CALL NO. 112
CONTRACT ID NO. 141246
ADDENDUM # 1

Subject: Warren County, NHPP 0651 (097)
Letting July 11, 2014

- (1) Revised - Plans - R2 & R2A
- (2) Revised - Bid Items - Pages 108-109 of 109

TYPICAL SECTIONS

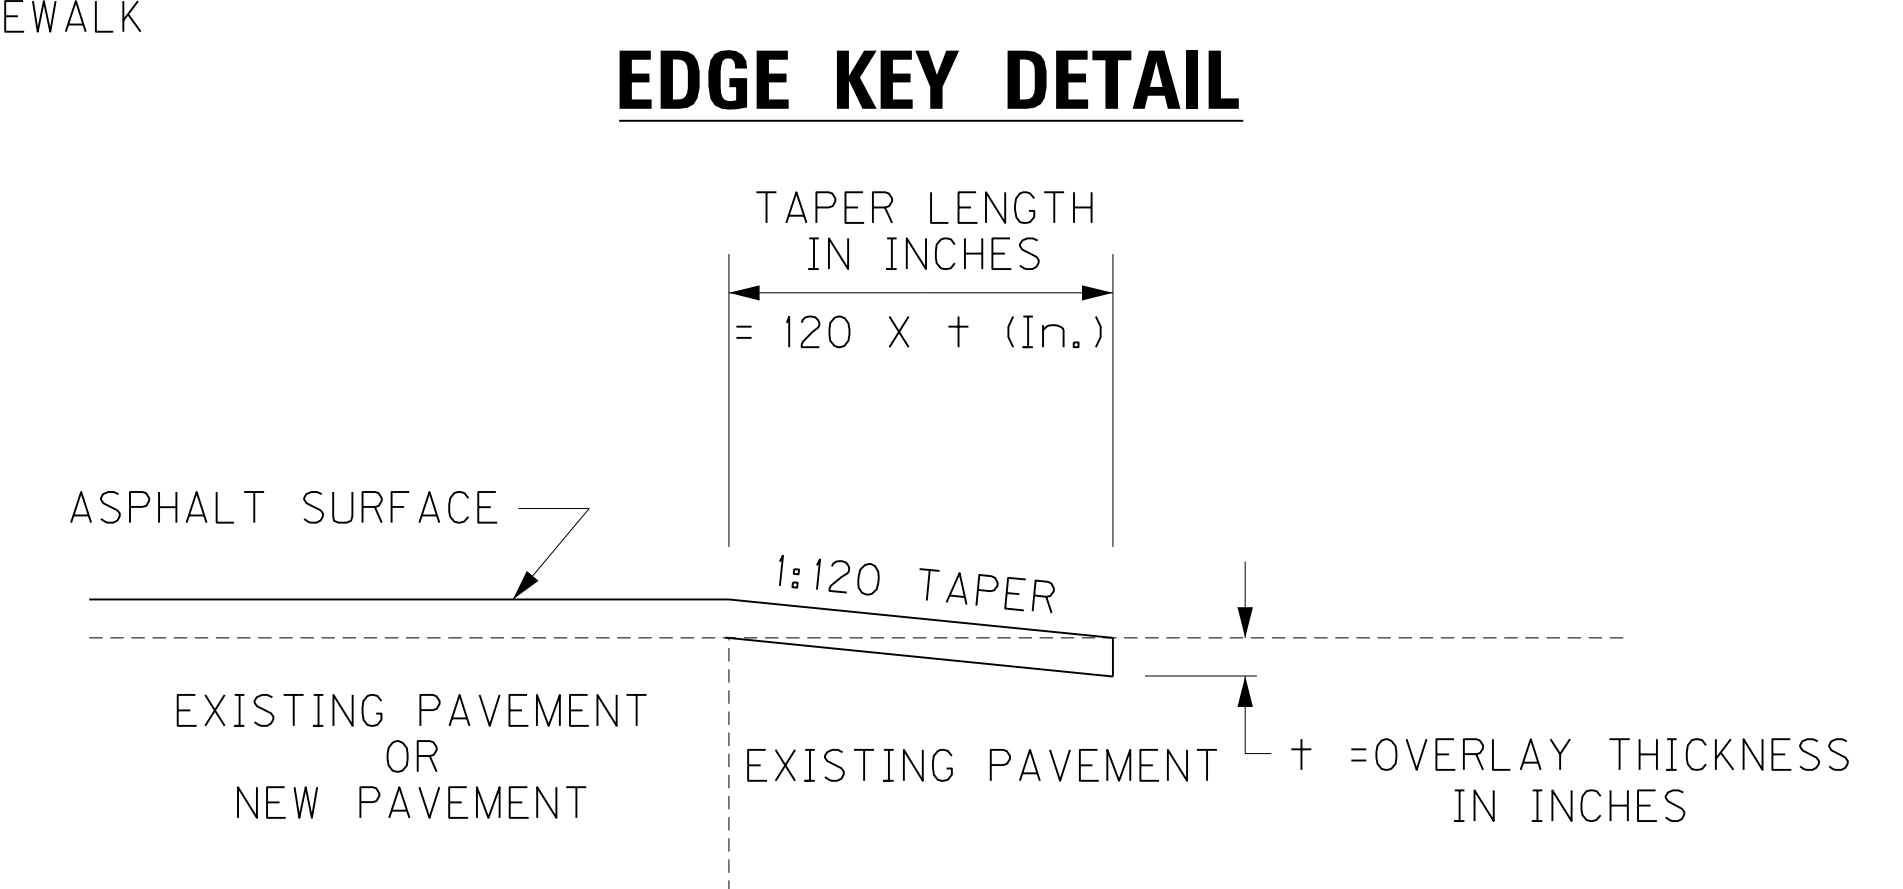
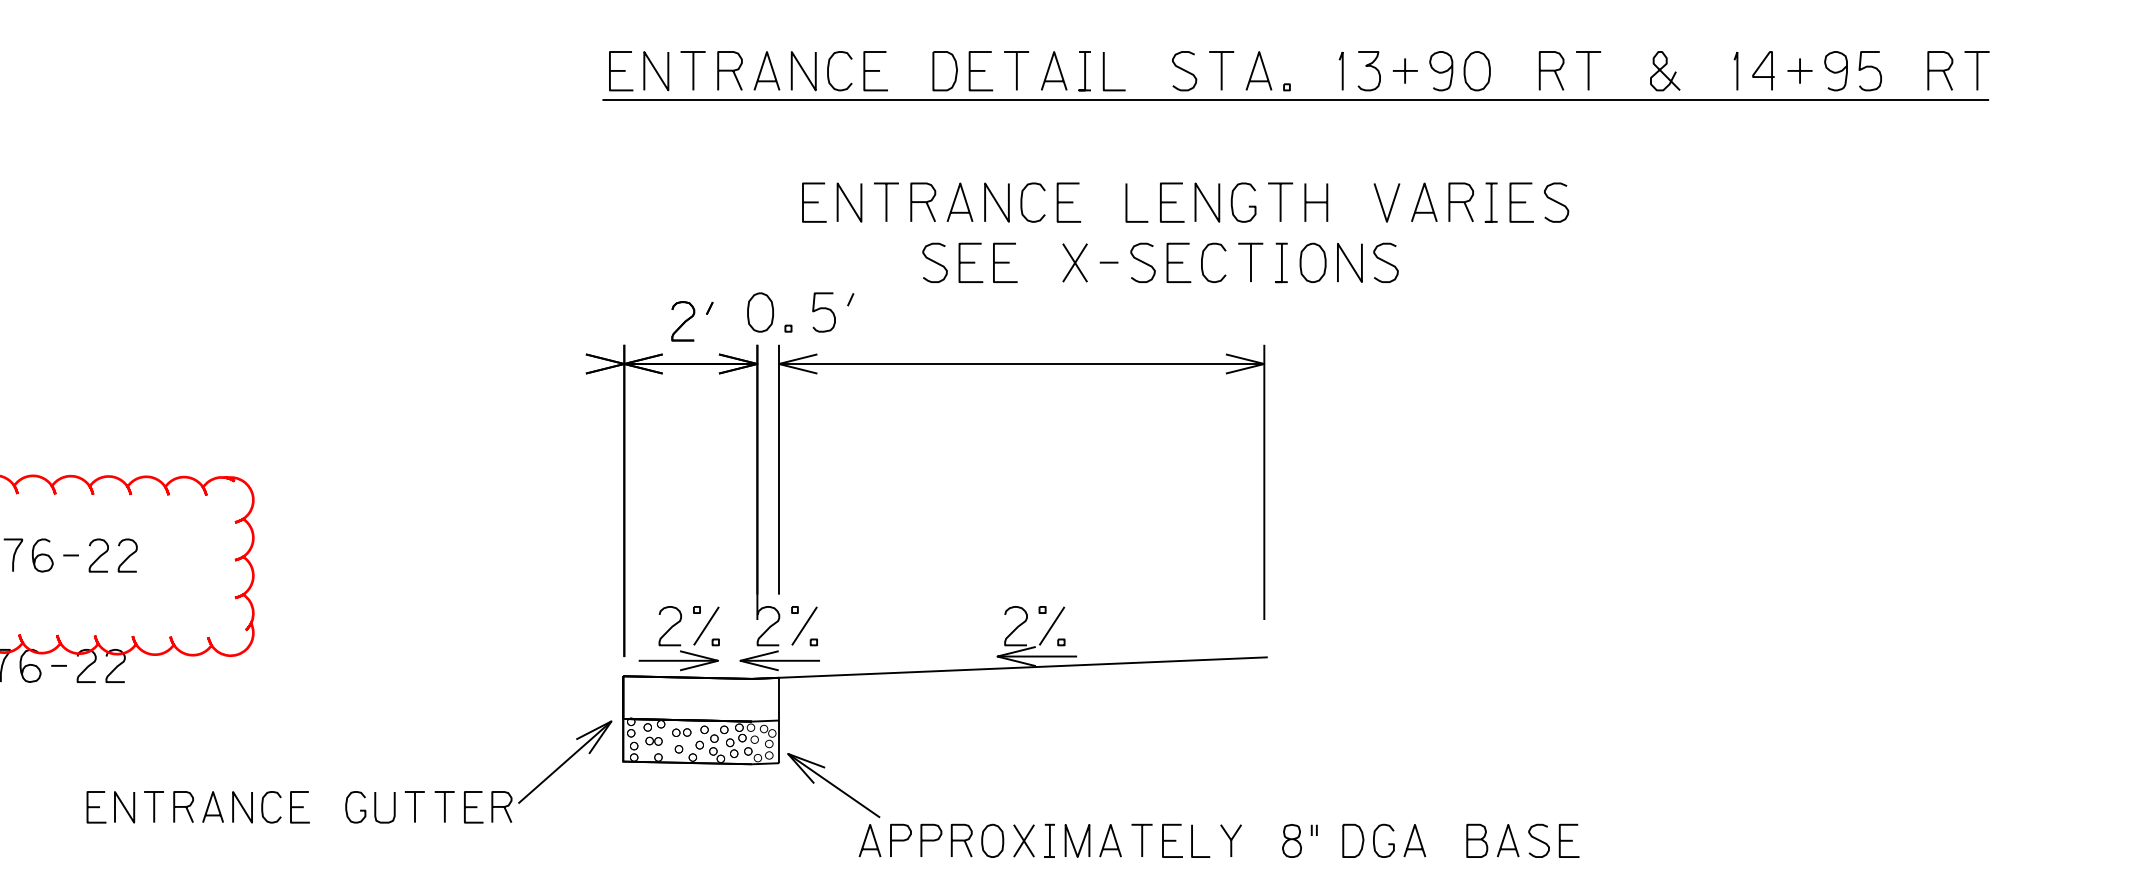
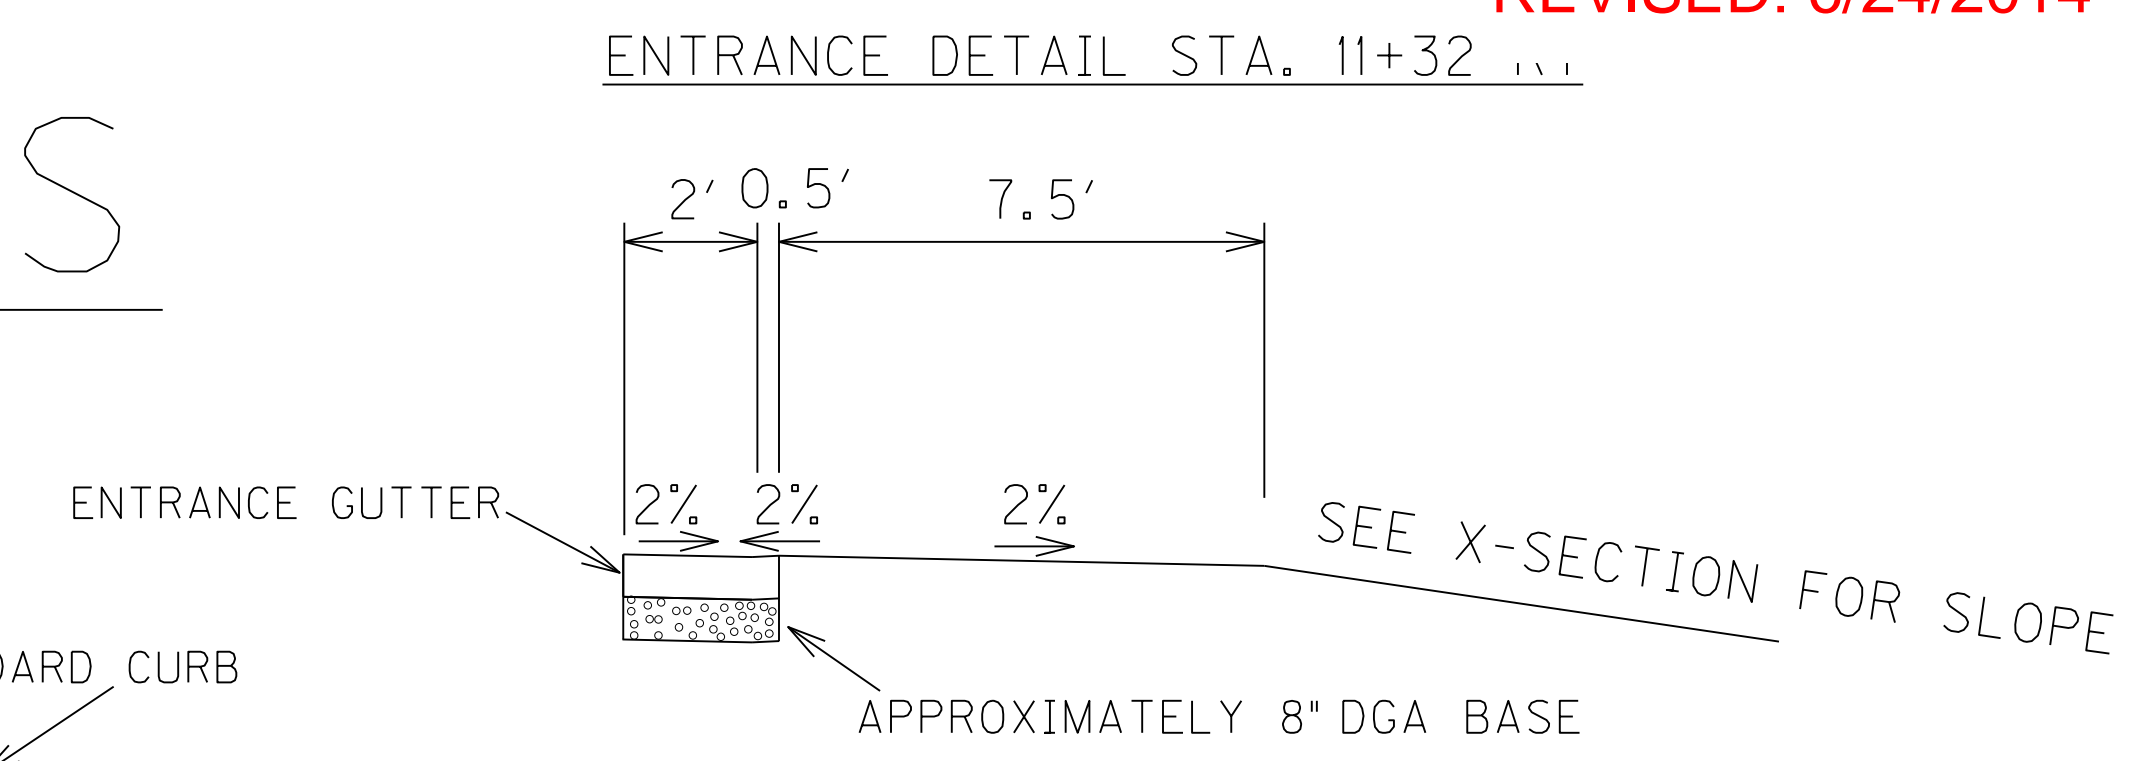
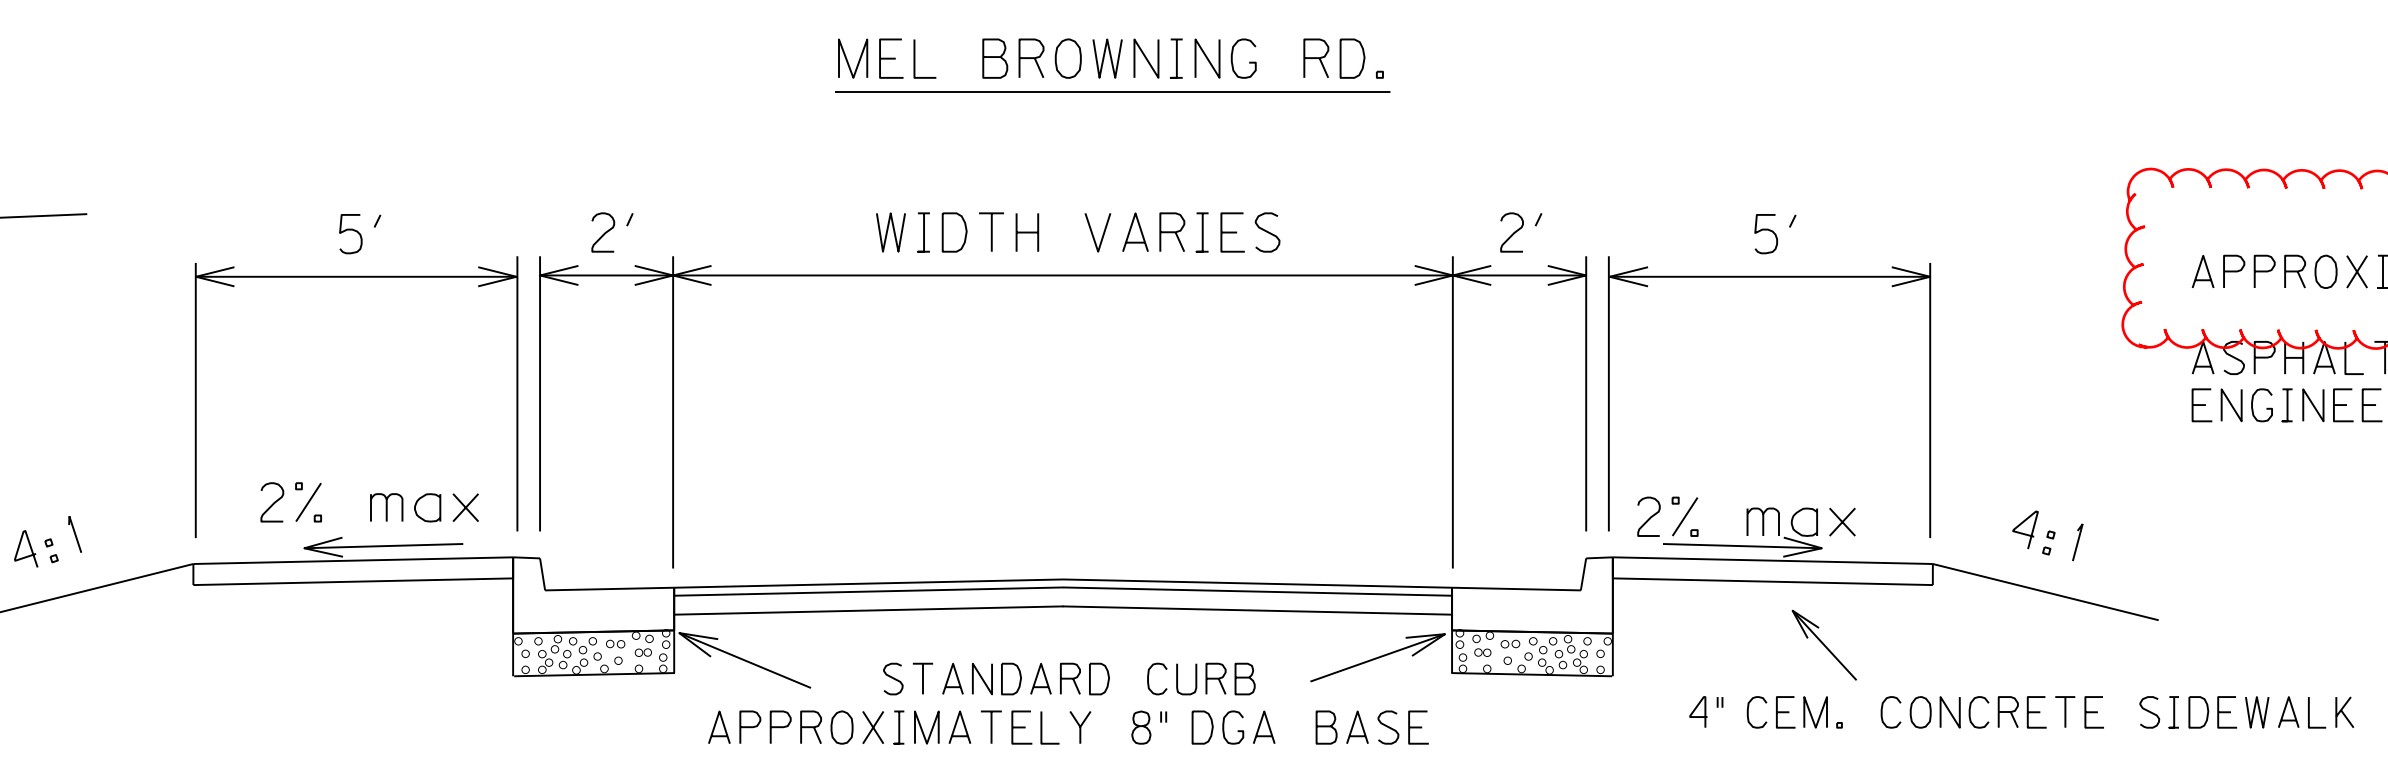
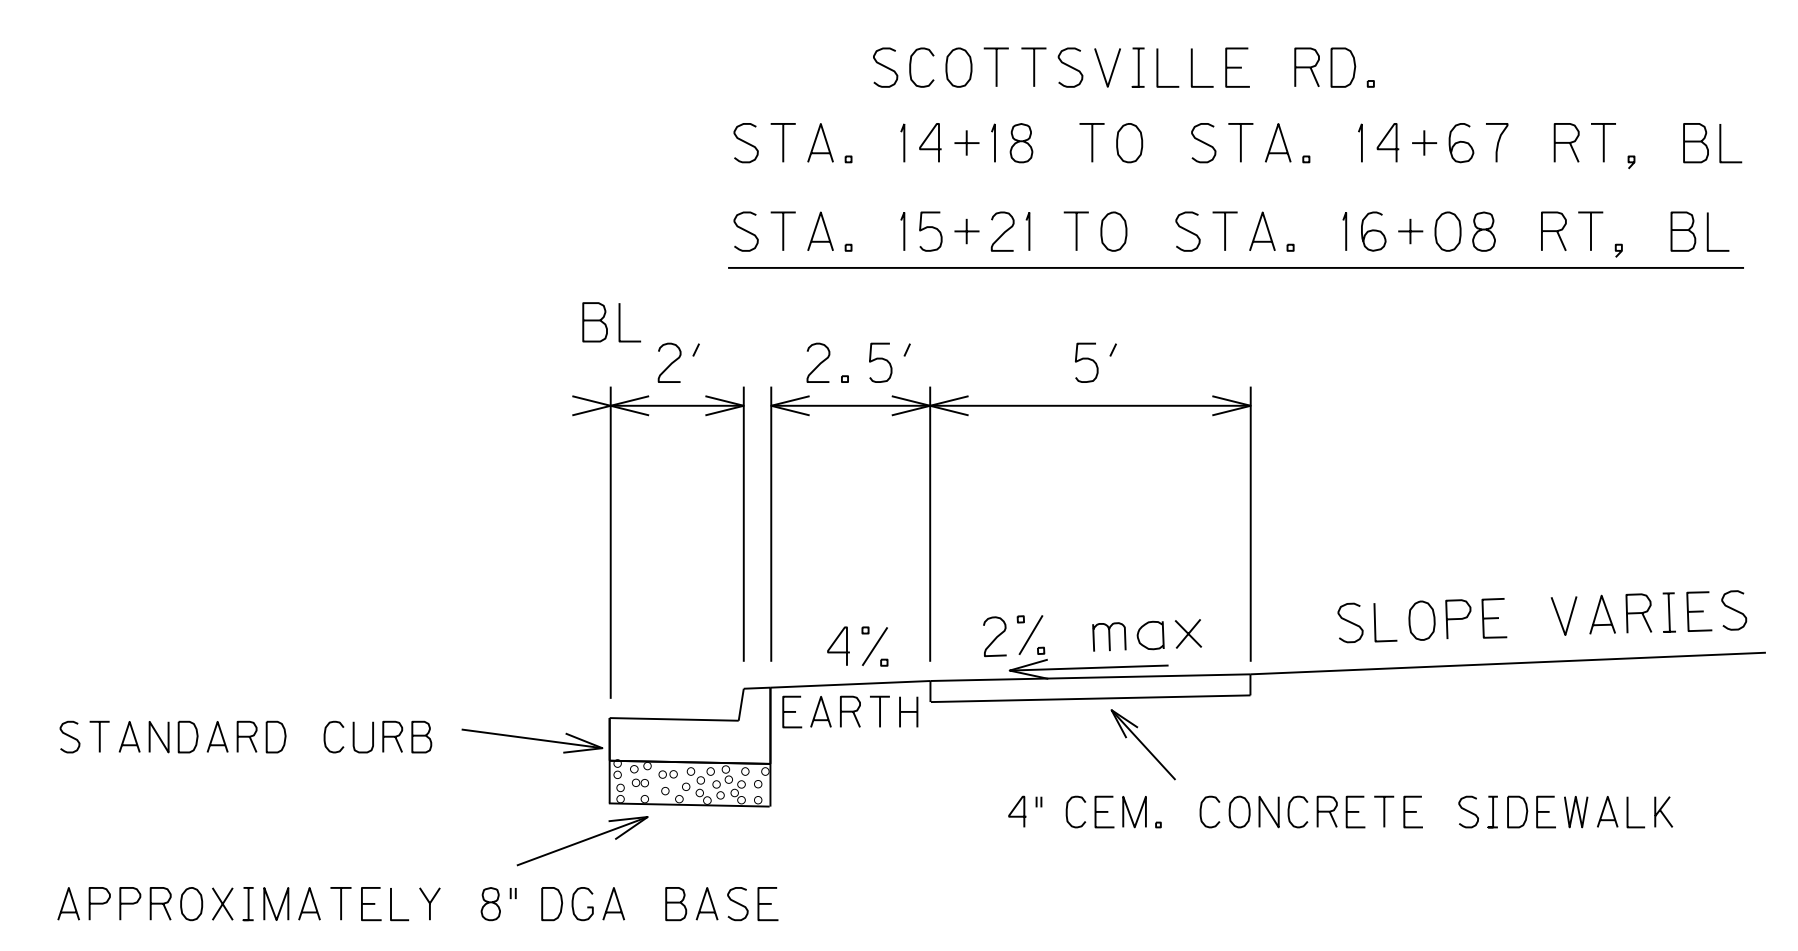
REVISED: 6/24/2014
